Jacob's Island Strategic Housing
Development, Co. Cork

Quality Audit

Document Ref:	P22-071-UQA-GEN-RP-001
----------------------	-------------------------------

4.3.1 Problem

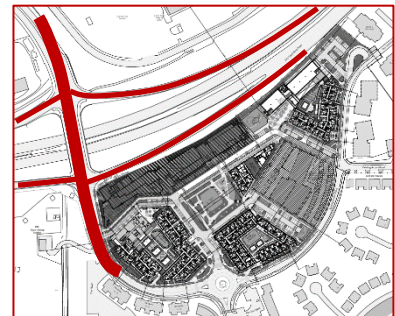
Summary: Existing crossings on Longshore Avenue may be unable to accommodate the increased volume of pedestrians and cyclists.

The new Strategic Housing Development may increase the volume of pedestrians wishing to cross Longshore Avenue, particularly during AM and PM peak periods. There may also be an increase in the volume of cyclists crossing Longshore Avenue. It is unclear if the existing Zebra Crossings will be capable of meeting additional crossing demand following the construction of the SHD site. Should the crossings be inadequate, there may be a risk of unsafe pedestrian and cyclist crossing movements, particularly where young children or mobility impaired pedestrians are using the crossing.

Ensure that the existing Zebra Crossings can support the expected pedestrian and cycle volumes likely to cross Longshore Avenue.

If Zebra Crossings are found to be adequate, significant maintenance/repair will be required to ensure the two existing Zebra Crossings are fully operational.

4.3.1	Yes	Yes		
4.3.2	No	No	A Traffic Assessment has been undertaken. There is currently no evidence of traffic queuing across the crossings, street lighting is provided at this junction which should alleviate any potential issues with darkness in winter periods.	Yes

4.3.3 Problem

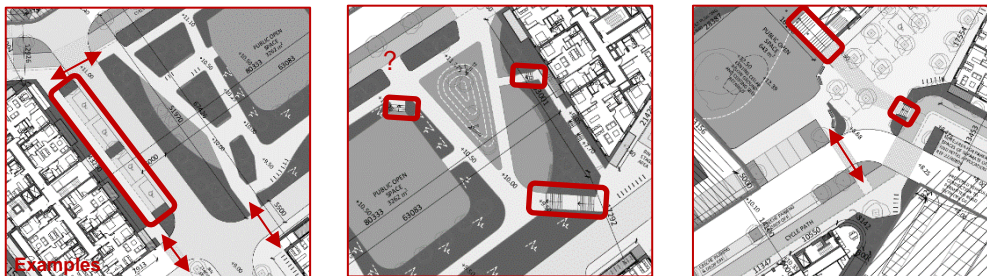
Summary: The location of trees may reduce intervisibility between road users.

The location of trees at side road junctions, pedestrian crossing points, perpendicular parking spaces, and the Zebra crossings on Longshore Avenue, may reduce intervisibility between drivers, and between drivers and pedestrians/cyclists. Reduced intervisibility may increase the risk of side-on collisions and vehicle/pedestrian and vehicle/cyclist collisions.

Ensure trees are located outside visibility splays.

4.3.3	Yes	Yes		
4.3.4	Yes	Yes		
4.3.5	Yes	Yes		
4.3.6	Yes	No	Whilst any such works on Longshore Avenue are outside the scope of this project, the Design team shall work with the Local Authority to investigate opportunities for improving connectivity to Mahon, and the local Greenway.	Yes

4.3.5 Problem

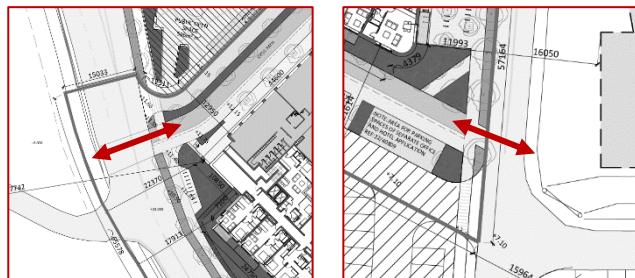
Summary: Junction control, and priority, has not been indicated at the crossroad junction.

The junction control (stop, yield etc.), and thus priority, at the development's internal crossroad junction has not been indicated. The absence of adequate road markings and signage may lead to driver confusion and hesitation resulting in drivers misinterpreting priority at the junction and entering the junction at the same time as opposing vehicles where there is an increased risk of side-swipe or side-on collisions.

Ensure the junction control, and priority, at the proposed crossroad junction is clear via signage and road markings.

4.3.6 Problem

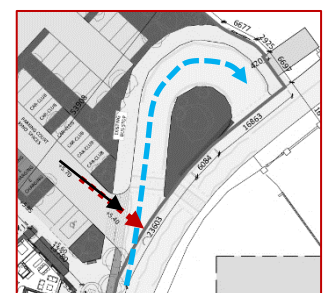
Summary: It is unclear how cyclists will safely cross Longshore Avenue at the extremities of the internal cycle track.

An internal cycle track is provided within the SHD site. The cycle facility connects with Longshore Avenue to the east and west of the development, however, no crossings have been indicated within the plan. It is therefore unclear how cyclists will safely access the opposite side of the road, where they can continue their journey. The absence of a crossing facility may lead to cyclists mounting a full height kerb to access the facility, which can increase the risk of falls and personal injuries, or cycling straight into the carriageway in front of a vehicle, leading to vehicle/cyclist collisions.

Additional facilities should be provided where the internal cycle track interfaces with Longshore Road, ensuring cyclists can safely access the cycle track from Longshore Avenue, or cross to the opposite side of Longshore Avenue when wishing to continue their journey toward Mahon in the north, or the amenities south of Longshore Drive.

4.3.10 Problem

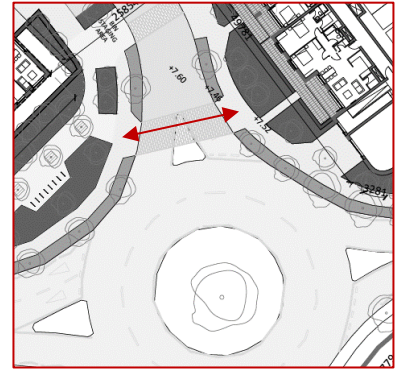
Summary: Possible slips, trips, and falls.

The proposed layout indicates an uncontrolled pedestrian crossing of the primary development access at the northern arm of the Longshore Avenue roundabout. However, the crossing appears to be on a ramp gradient, which may increase the risk of pedestrians crossing on a surface that is not level, leading to slips, trips, and falls.

Ensure the uncontrolled pedestrian crossing is located on a flat, level, surface, and that provision for the crossing is made within the splitter island. Tactile paving and dropped kerbs should be provided at the crossing.

4.3.7	Yes	Yes		
4.3.8	Yes	Yes		
4.3.9	Yes	Yes		
4.3.10	Yes	Yes		
4.3.11	Yes	Yes

4.3.11 Problem

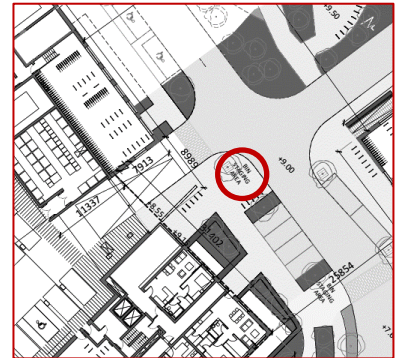
Summary: Bins storage areas may obstruct visibility for drivers when located at accesses or side roads.

Bin Staging areas are located within the development. However, some areas are located near side road junctions or vehicle accesses, which may reduce visibility for drivers using the development. This may lead to drivers entering the road when it is unsafe to do so, leading to side-on or vehicle/cyclist collisions.

Ensure bin storage areas do not reduce or block visibility.

4.3.12 Problem

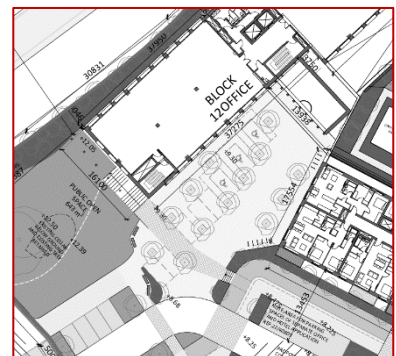
Summary: Planter boxes may obstruct the safe entry and exit of vehicles in the Office Block 12 carpark.

Several planter boxes have been located near mobility parking spaces within the Office Block 12 carpark. It is unclear if these planter boxes will obstruct safe entry/exit movements for drivers using the carpark. Should the planter boxes restrict vehicle movement, there is an increased risk of material damage collisions.

Ensure planter boxes near Mobility Parking spaces do not interfere with a vehicle's swept path near Block 12.

4.3.12	Yes	No	<p>All trees scheduled in close proximity to the mobility parking spaces at Office Block 12 are all 'in ground' and to fully clarify there are no above planters proposed within this zone.</p> <p>All 'in ground' trees proposed shall have a clear stem of 2.0m in height to offer intervisibility through the space.</p> <p>All specimen trees shall also be fastigate in nature which in effect will ensure they are narrow in form in terms of their canopy width and will retain their shape and compactness upon establishment. In this instance, the buffer area (i.e. 1200mm width) at each of the designated parking spaces has been duplicated to ensure the trees can be included throughout whilst not impacting on the Part M Building Regulations relating to the same.</p>	<p>Yes</p> <p><i>(Note, tree canopies should be cut to a height of 2.5m to permit cyclists)</i></p>

5.13.1 Issue

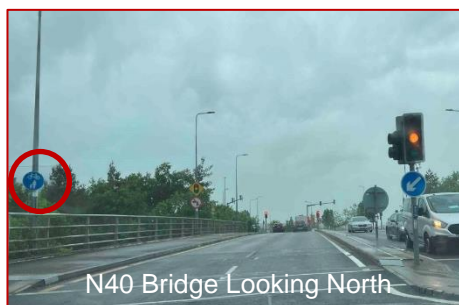
Electric Vehicle (EV) parking spaces have not been indicated within the development's basement carpark; however it is likely that a portion of the parking spaces will be required for EVs. These spaces typically require additional width to support a buffer zone to account for potentially different charging port connections on vehicles. The additional width allows space for electric cables, as well as user access to connect/disconnect the charging cables.

All the parking spaces, with the exception of mobility impaired parking spaces, within the carpark, appear to have similar dimensions. There is a risk therefore that, should any of these spaces be designated for EVs as the design progresses, the required space will not be available to accommodate the necessary buffer zone and infrastructure for EV parking spaces.

A sufficient number of parking spaces within the development's carparks should be designated as EV parking spaces and sufficient space should be provided at these spaces in accordance with Section 7.6.16 of the Traffic Signs Manual (2019), Chapter 7 'Road Markings.'

6.1.1 Issue

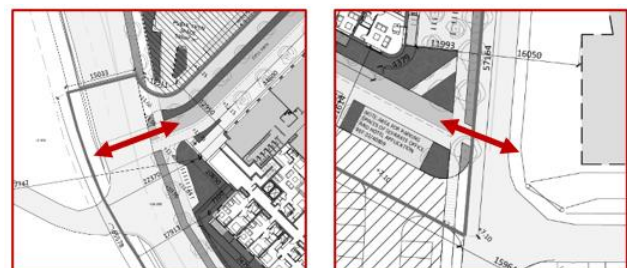
The proposed cycle track within the SHD site connects externally with Longshore Avenue to the east and west of the development, however, no crossings have been indicated within the plan. It is therefore unclear how cyclists will safely access the opposite side of the road, where they can continue their journey. This may discourage cyclists from travelling to and from the development.

Additional facilities should be provided where the internal cycle track interfaces with Longshore Road.
